Urgent Field Safety Notice

Commercial name of the affected product: Zilver PTX Drug-Eluting Peripheral Stent

FSCA-identifier: 2012C0005

Type of action: Labelling modification

Figure 1 - Zilver PTX inner catheter, A - pusher band B - stent retention area (length correlates to stent length) C – white tip, radiopaque (length = 2 cm). Inner catheter separation observed immediately proximal or distal to pusher band (A).

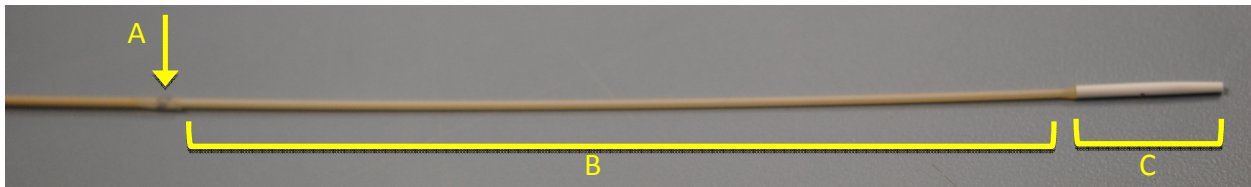
Observation 1: To prevent any unrecognized tip/inner catheter separation, it is recommended to check the delivery system after removal from patient to make sure the tip is intact (maintain wire guide access until this check is completed). This device's delivery system includes an inner catheter loaded within an outer (Flexor) sheath. A 2 cm white tip extends from this inner catheter, and is visible beyond the distal end of the Flexor sheath. The reported delivery system separations have included this white tip and an adjoining segment of inner catheter ranging from approximately 8 to 15 cm in length. Since only the white tip itself is radiopaque, it is important to understand there could possibly be a larger fragment *in situ* than is evident from x-ray images.
